830- AND 2830-TYPE  
TELEPHONE SETS  
(4-WIRE RELAY CONNECTIONS)

1.001 This Addendum supplements Section 503-701-101. Place this sheet ahead of Page 1 of this section.

1.002 This Addendum is issued to show the P-90D145 wiring board used in the modification of the 830- and 2830-Type Telephone Sets for 4-wire operation.

EXHIBIT 1

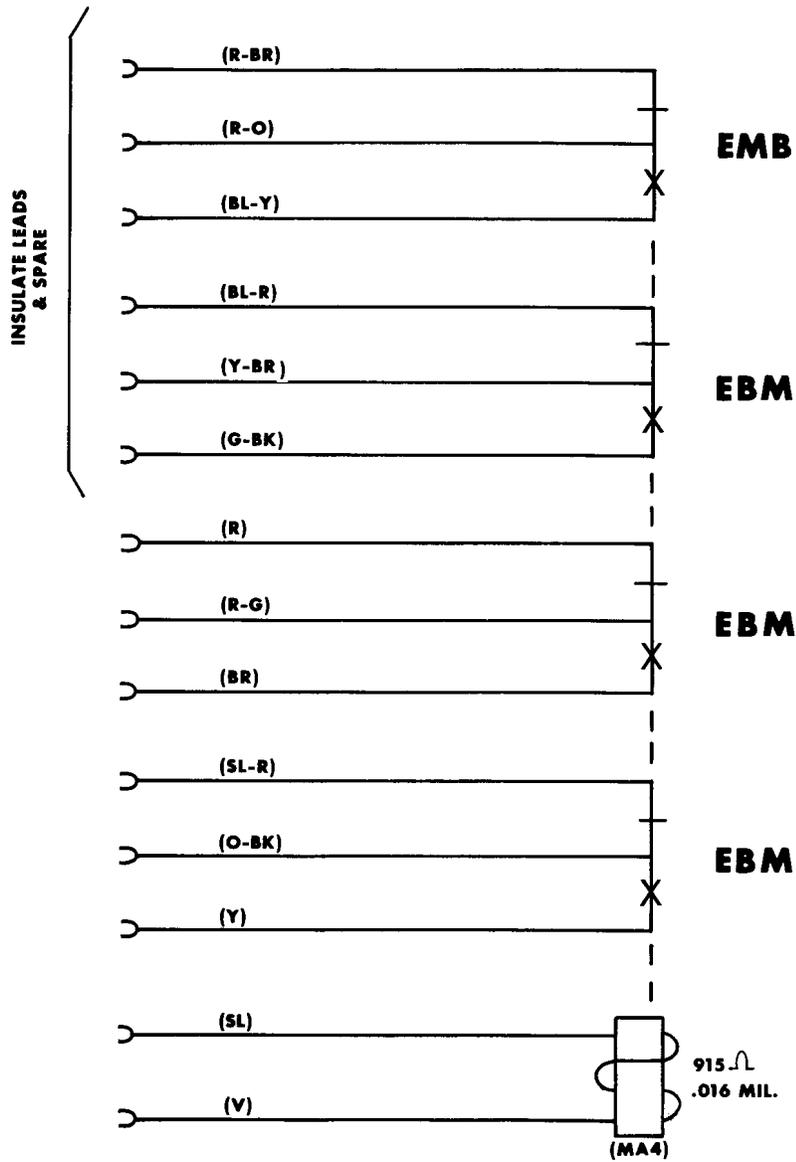
6.003 Exhibit 1 shows the wiring schematic for the P-90D145 wiring board. The relay is mounted on a wiring board which contains holes for mounting in the set.

EXHIBIT 2  
MODIFICATION OF 830-TYPE TELEPHONE SETS  
FOR FOUR-WIRE OPERATION

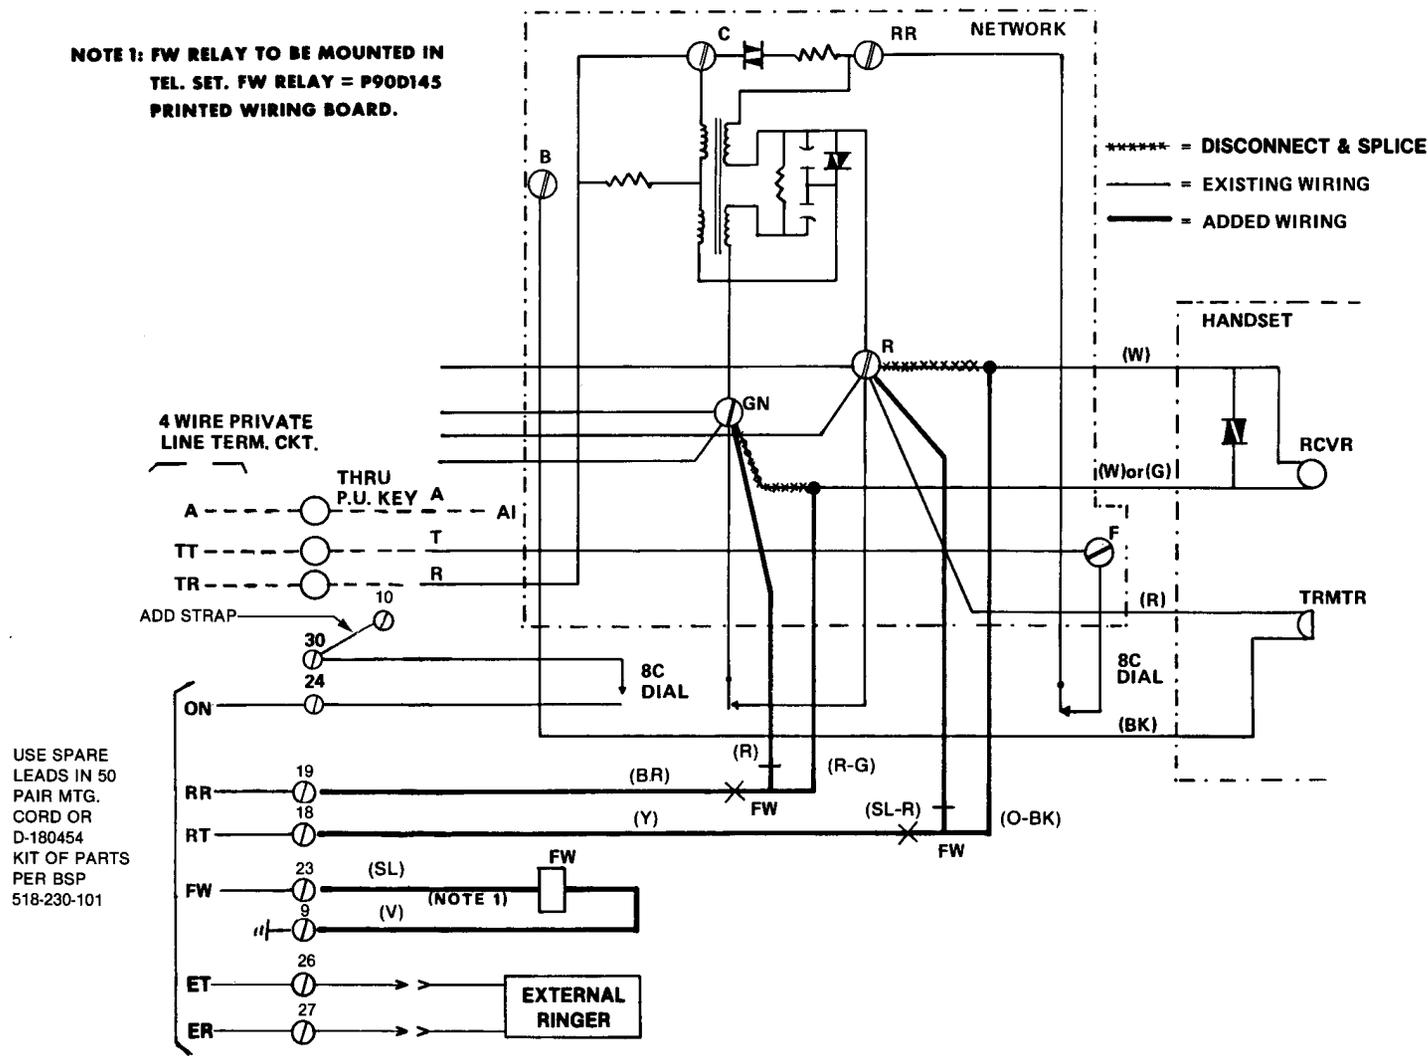
6.002 The 830- and 2830-Type Telephone Sets are to be modified as shown in Exhibits 2 and 3. The P-90D145 wiring board is to be mounted inside the telephone set and wiring should be spliced as required. Spare leads in the 50 pair Mtg. Cord may be used for connecting to the 4-wire circuit equipment if available. A D-180454 Kit-of-Parts may be used if spare leads are not available. (See Section 518-230-101).

NOTE: When modifying an 830-Type set, the 8RA Dial must be replaced with an 8CA Dial.

**NOTE 1: FW RELAY TO BE MOUNTED IN TEL. SET. FW RELAY = P90D145 PRINTED WIRING BOARD.**

USE SPARE LEADS IN 50 PAIR MTG. CORD OR D-180454 KIT OF PARTS PER BSP 518-230-101
